AMENDMENTS TO THE DRAWINGS

REMARKS

This is intended as a full and complete response to the Final Office Action dated January 25, 2006, having a shortened statutory period for response set to expire on April 25, 2006. Please reconsider the claims pending in the application for reasons discussed below.

Fig. 1

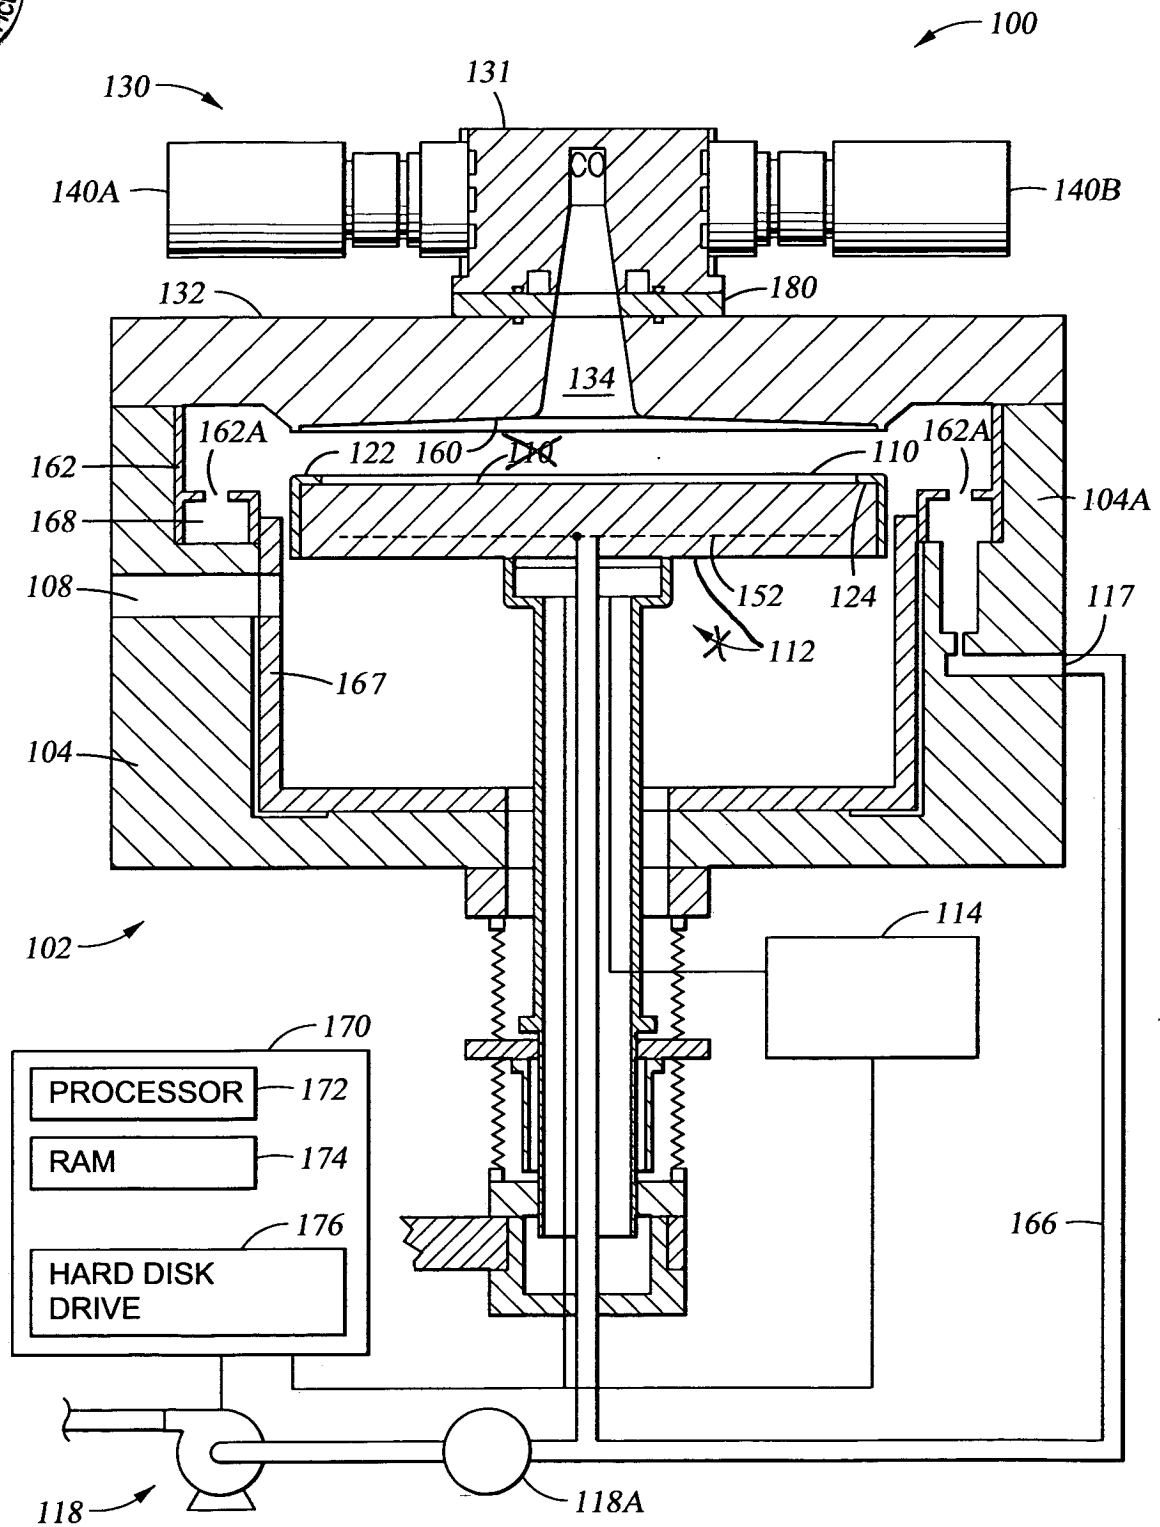
Replacement Sheet 1, Figure 1 – An excess element numeral 110 was removed, element numeral 112 was redirected, and the hatching of element 180 was amended within the figure;

Fig. 5A

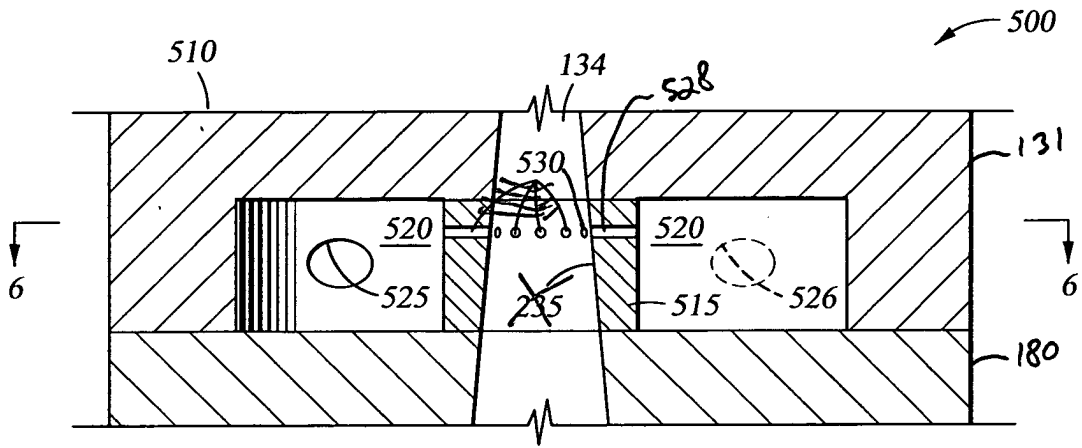
Replacement Sheet 4, Figure 5A – Element numerals 131, 180, and 528 were added, element numeral 235 was removed, the hatching of element 180 was amended, and element numeral 530 was redirected within the figure;

Fig. 5B

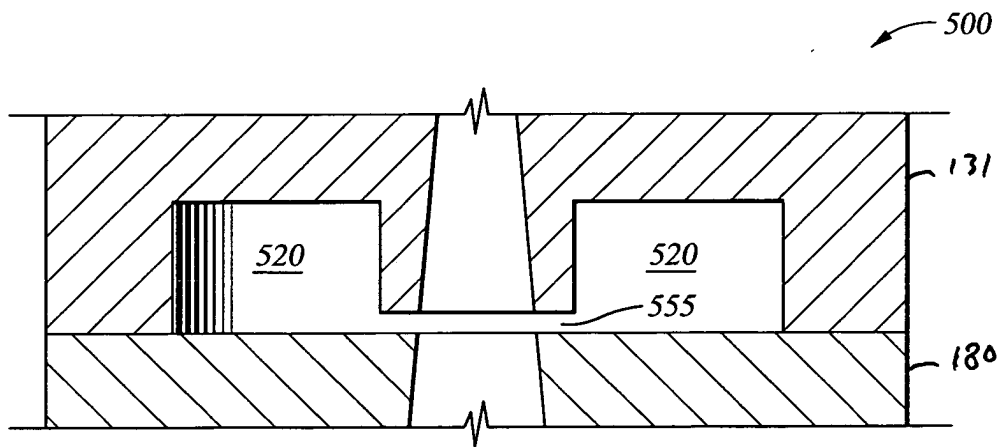
Replacement Sheet 4, Figure 5B – Element numerals 131 and 180 were added and the hatching of element 180 was amended within the figure;

Fig. 6

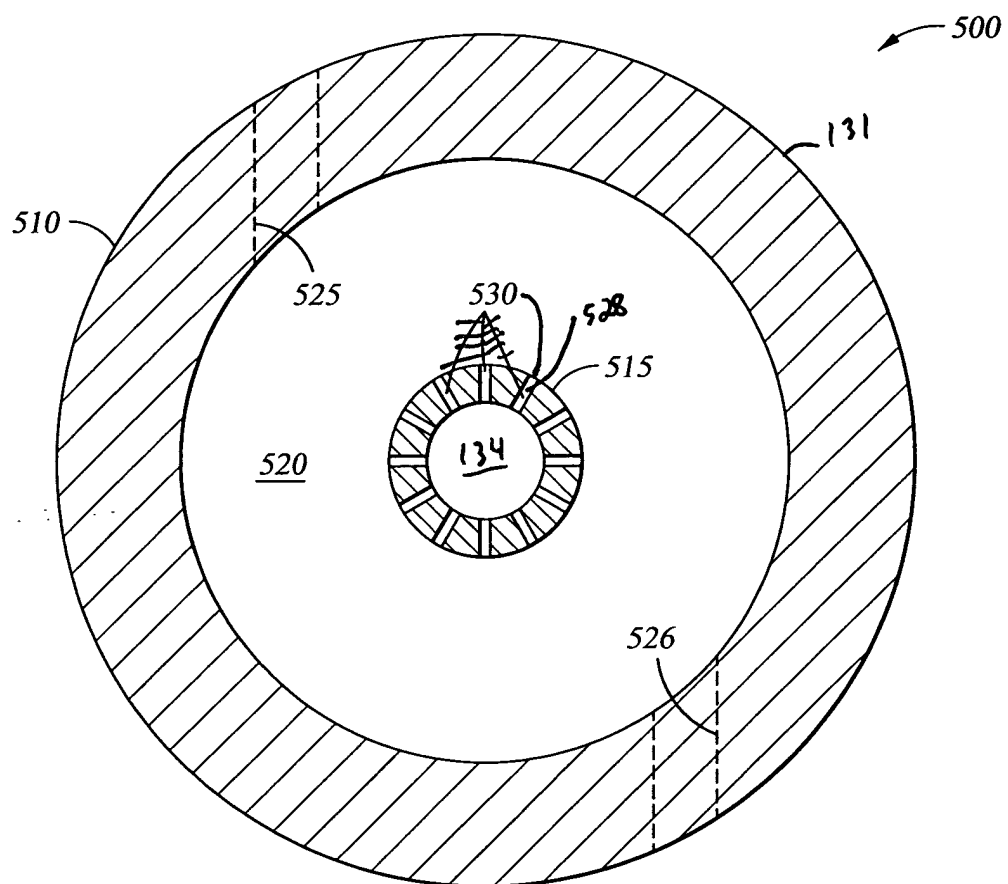
Replacement Sheet 5, Figure 6 – Element numerals 131, 134, and 528 were added and element numeral 530 was redirected within the figure;

Fig. 6A

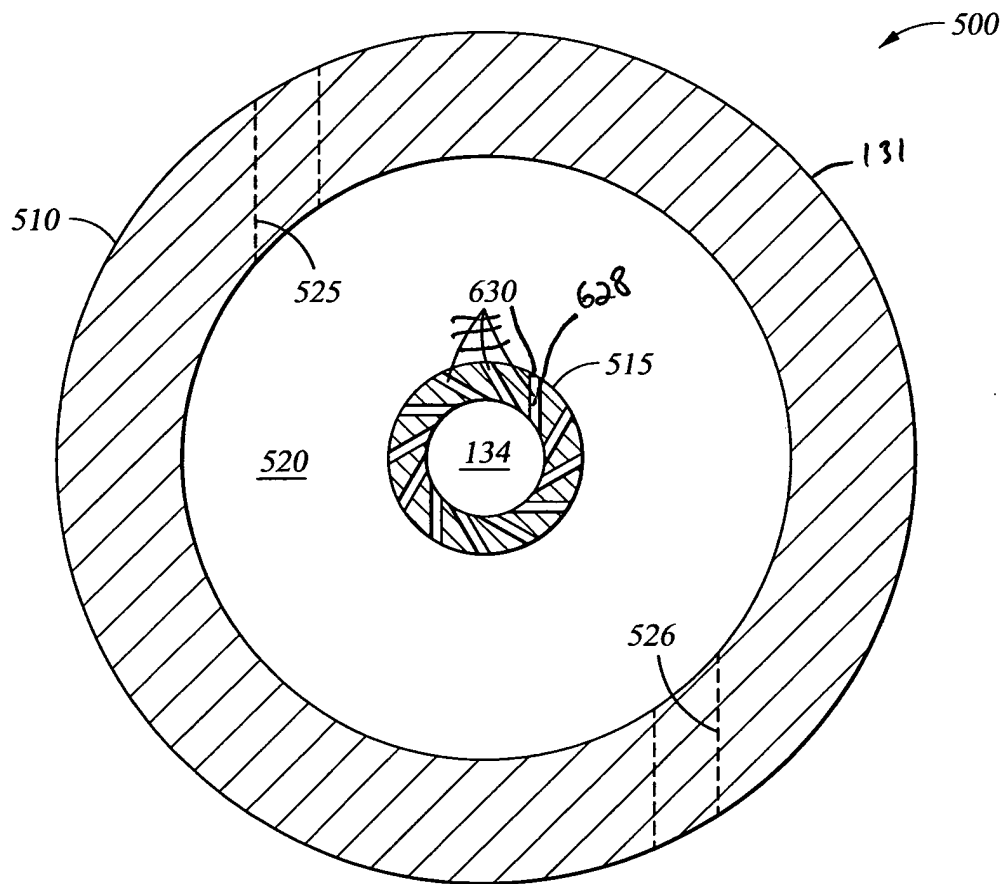
Replacement Sheet 6, Figure 6A – Element numerals 131 and 628 were added and element numeral 630 was redirected within the figure;

Fig. 7A

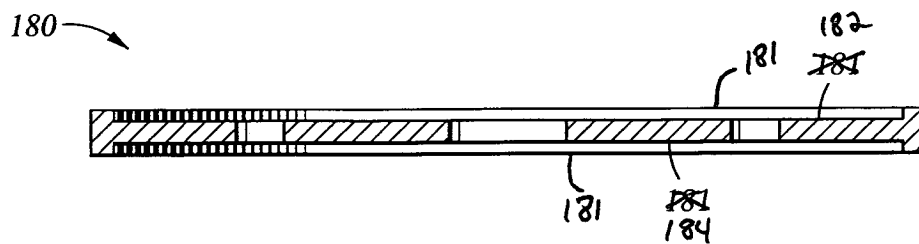
Replacement Sheet 7, Figure 7A – Element numerals 182 and 184 were added and element numeral 181 was redirected within the figure;

Fig. 8A

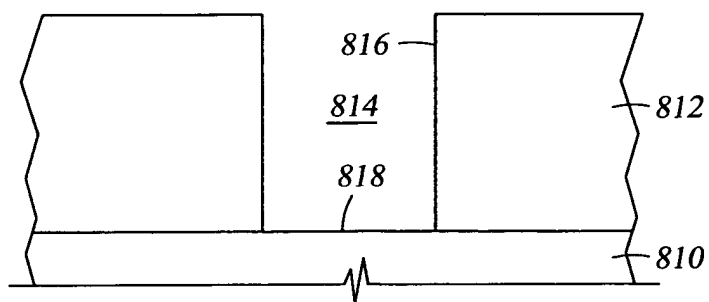
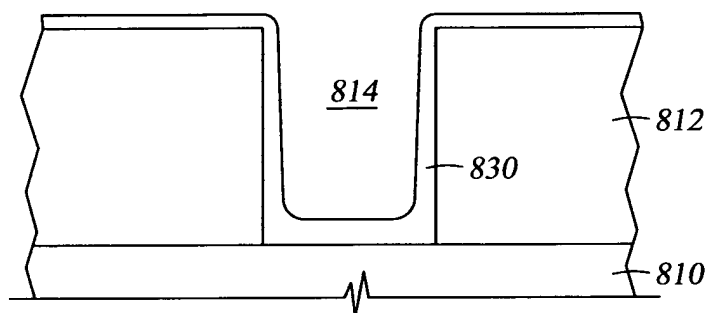
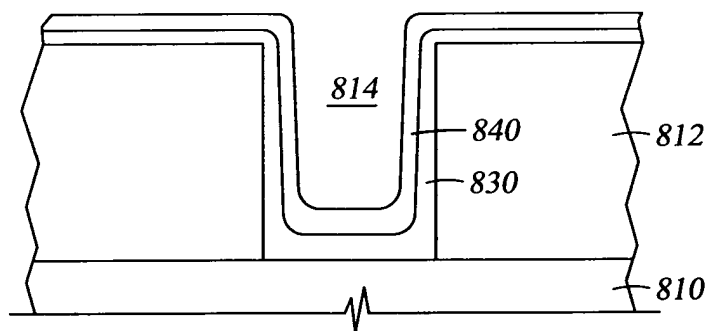
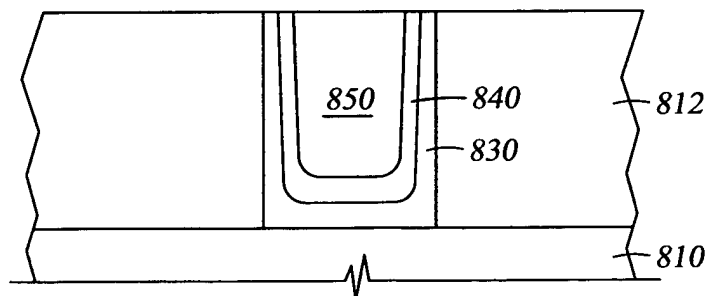
Replacement Sheet 8, Figure 8A-8D – Element numeral 800 was added within the figure; and

Fig. 9

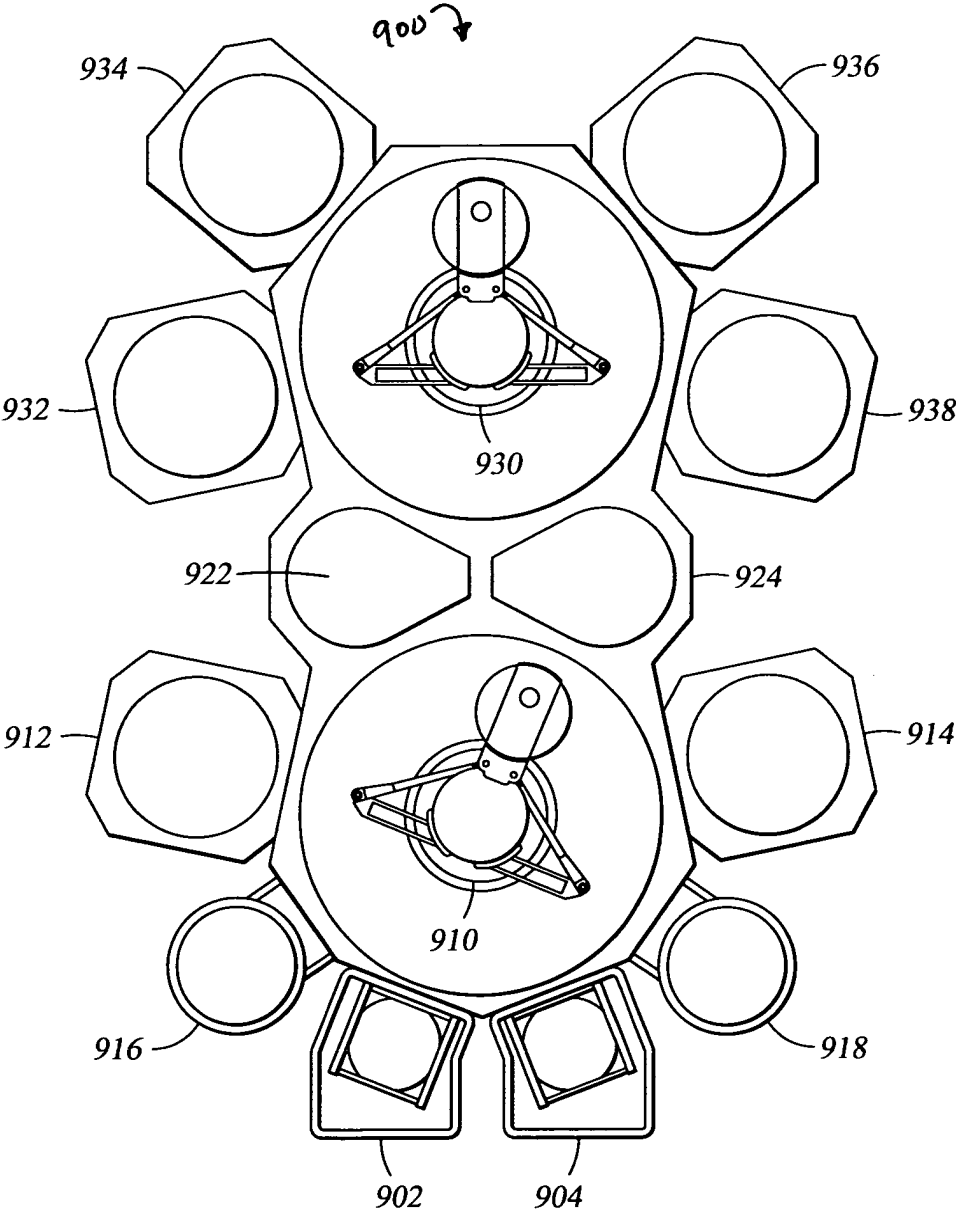
Replacement Sheet 9, Figure 9 – Element numeral 900 was added within the figure.
